TACO BELL SP 07-37A

TACO BELL, SITE PLAN NUMBER 07-37A

PLANNING REVIEW

Taco Bell
SP #07-37A

REDUCED SITE PLAN

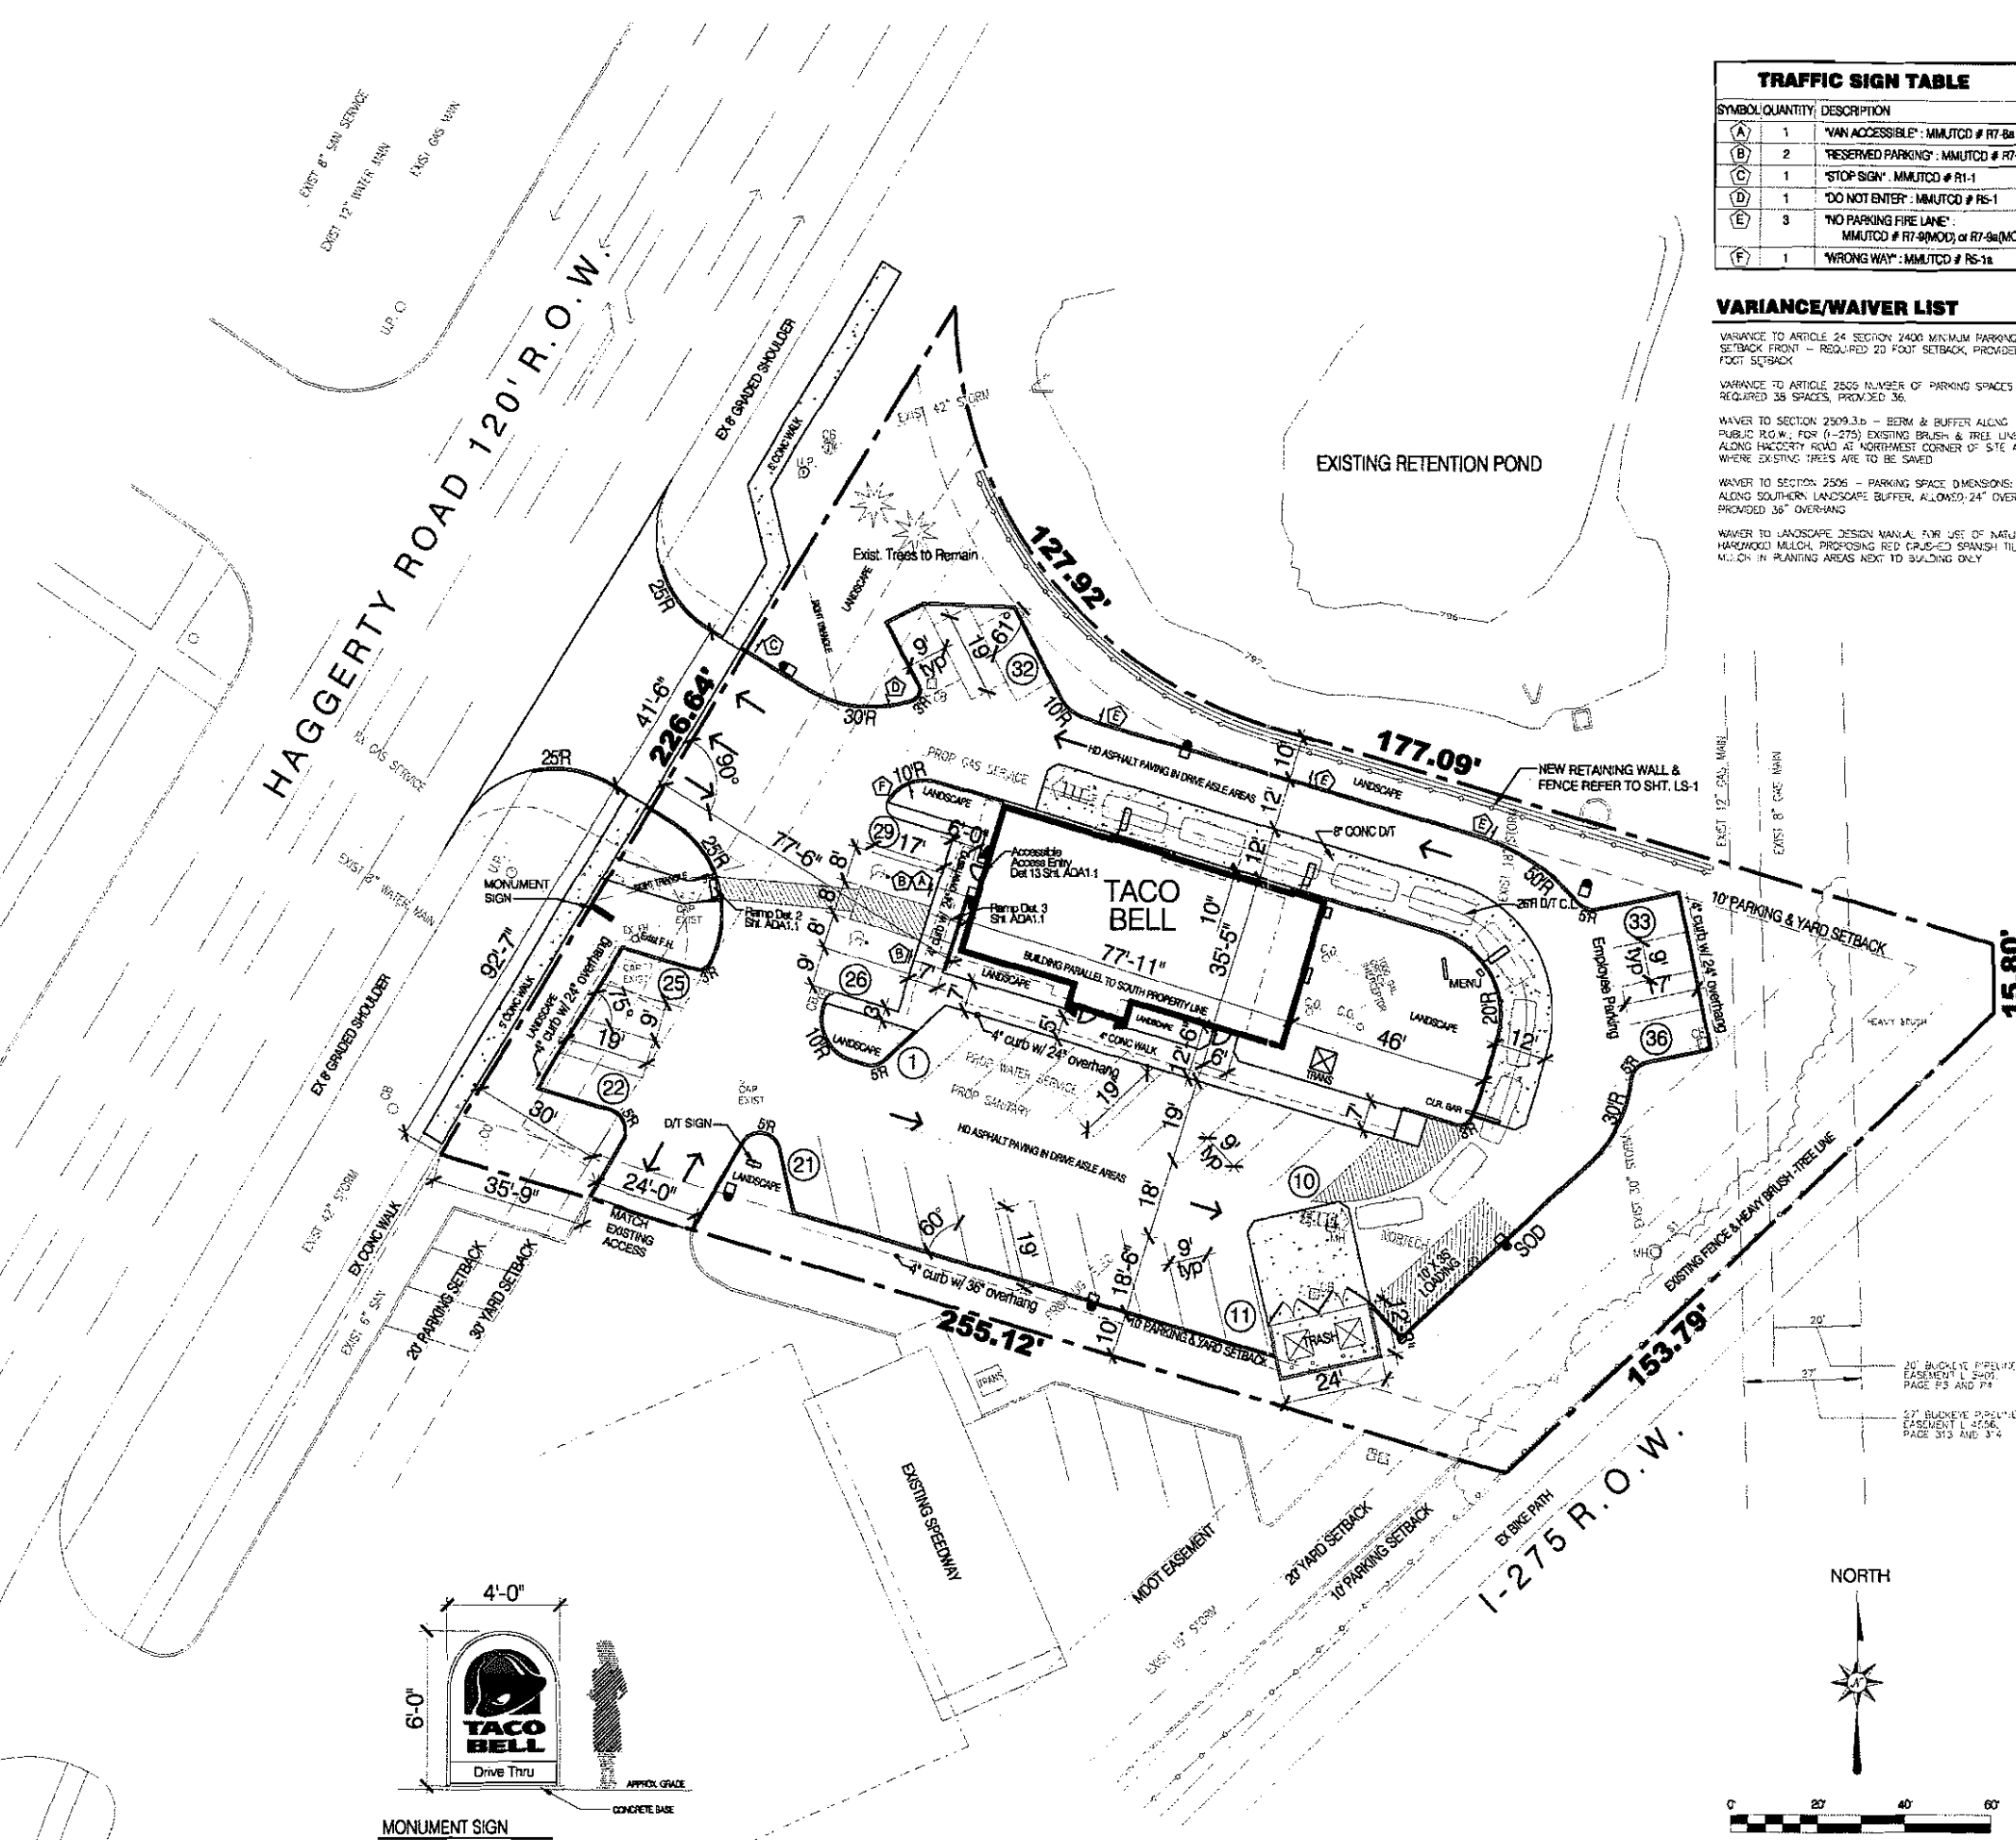
1. Parking Setback: In the FS district, the front yard parking setback is twenty feet. The proposed plan indicates a front yard parking setback of ten feet. The Planning Commission did state in the October 24, 2007 meeting minutes that they would not be opposed to seeing parking spaces included in this location. **The applicant should adjust the site layout to accommodate the front yard parking setback or seek a variance from the Zoning Board of Appeals.**

2. Number of Parking Spaces: Thirty-eight parking spaces are required per the standards set forth in Section 2505 of the Zoning Ordinance. Thirty-six spaces have been provided. Previously, the parking standard for a fast food restaurant (which requires considerably more spaces) was applied to this site. Per the direction of the Planning Commission, and based on representations of the volume of business typically found at this Taco Bell, the parking standard for a drive-through restaurant was applied for the revised Preliminary Site Plan. However, the applicant is still two spaces short of the required number of spaces. **The applicant should add two additional spaces or seek a variance from the Zoning Board of Appeals**

3. Loading Zone Screening: In the FS district, view of loading and waiting areas must be shielded from rights of way and adjacent properties. **Screening should be increased on the western property boundary or the applicant should seek a variance from the Zoning Board of Appeals.**

5. Lighting: **The applicant should add the required notes identified in the attached lighting review chart to the photometric plan.**

3. A 20' parking setback is required. The Applicant has proposed a 10' setback for a portion of the Haggerty frontage. **This would require a Planning Commission waiver.** Please note that this is a currently existing condition.

1. **Entry Doors:** We noted that both the entry doors to the proposed development open outward. We had suggested that concrete walk of at least 5' clear width should be provided and dimensioned, in order to provide an accessible pathway for handicapped individuals. To achieve this, the Clear width of 5' should be provided from the outer edge of the *open doors* to the line of 2' *overhang* by the parked vehicles.

3. **ADA Ramps:** The details of ADA ramps provided on sheet ADA 1.1 are obsolete. They should be eliminated from the plan set. The most recent MDOT details for ADA-compliant sidewalk

32. The City minimum required width for parking stalls is 9-feet, measured from the face of the curb. The parking stall furthest right in the northwest portion of the site does not meet this requirement.
33. Dimensions of parking stalls abutting a curb or sidewalk are to the face of curb or walk. All other dimensions are to back of curb unless otherwise indicated.
34. Show the sidewalk cross section and detail on the paving plan. Also, show the required 2-percent cross-slope to the sidewalk detail.
35. Detectable warning surfaces are required along Haggerty Rd as well. Specify the product proposed to be used for the detectable warning surface for barrier free ramps on the plans. The product shall be the concrete-embedded detectable warning plates, or equal, and shall be approved by the Engineering Department. Stamped concrete will not be acceptable.

- Item 1: Parking Setback encroachment will be addressed by seeking a variance from the Zoning Board of Appeals.
- Item 2: Parking Space deficiency will be addressed by seeking a variance from the Zoning Board of Appeals.
- Item 3: Loading zone screening will be addressed by seeking a variance from the Zoning Board of Appeals.
- Item 4: Dumpster enclosure setback encroachment will be addressed by seeking a variance from the Zoning Board of Appeals.
- Item 5: Lighting review notes will be added to the photometric plan.

- Item 1: Do to site constraints the 5' entry door clearance cannot be met; we have provided 4' clearance at front entry and 3' clearance at side entry.
- Item 2: Barrier free parking signs will be moved out of the 2' overhang area.
- Item 3: Sheet ADA1.1 will be eliminated and ADA ramp details will be added to sheet C-8.
- Item 4: Typical parking stall will be dimensioned as indicated.
- Item 5: The correct MMUTCD code and sign mounting heights will be corrected as indicated.

- 1) Requesting P.C. waiver for landscape berm along the MDOT frontage.
- 2) Landscape berm along Haggerty road will be corrected as noted.
- 3) Requesting P.C. waiver for parking setback deficiency.
- 4) All planting quantities will be verified.
- 5) Planting heights in 25' clear vision areas will be noted.
- 6) Cross section of landscape berm will be provided.
